**OFFICIAL NOTICE & AGENDA**  
REGULAR MEETING

**MEETING:** Board of Public Works  
**DATE/TIME:** Tuesday, June 30, 2026, at 10:30 AM  
**LOCATION:** Wausau City Hall — Council Chambers  
407 Grant Street, Wausau WI, 54403

# CHANGE ORDER

| <b>PROJECT:</b>    | 2026 Street Construction Project "A"                              | <b>CHANGE ORDER NO. 1</b> |

1999 Plans and 1961 Plans

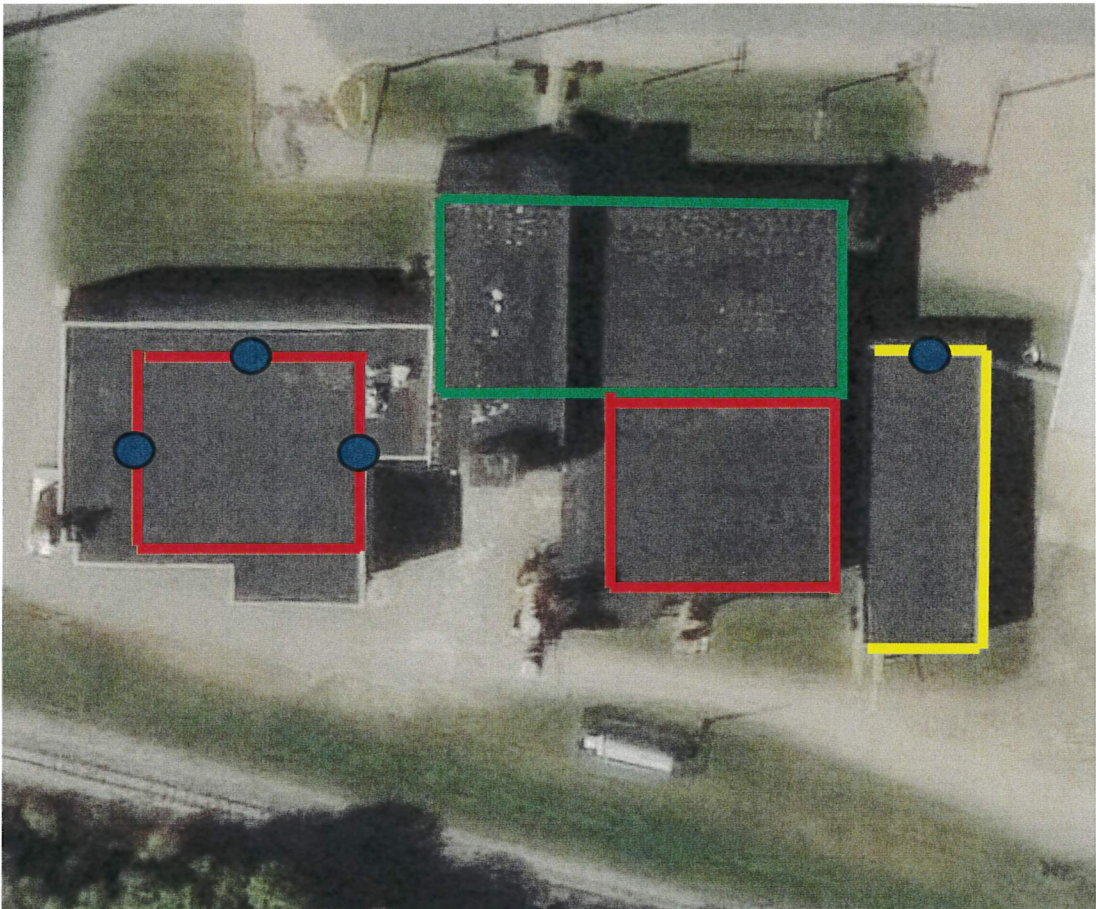
The foundations and walls were discovered below the elevation of 1187, which was the specified depth for removal of the footings and foundations. This change order is to remove the foundations and walls below 1187, with the exception of the water storage tank.
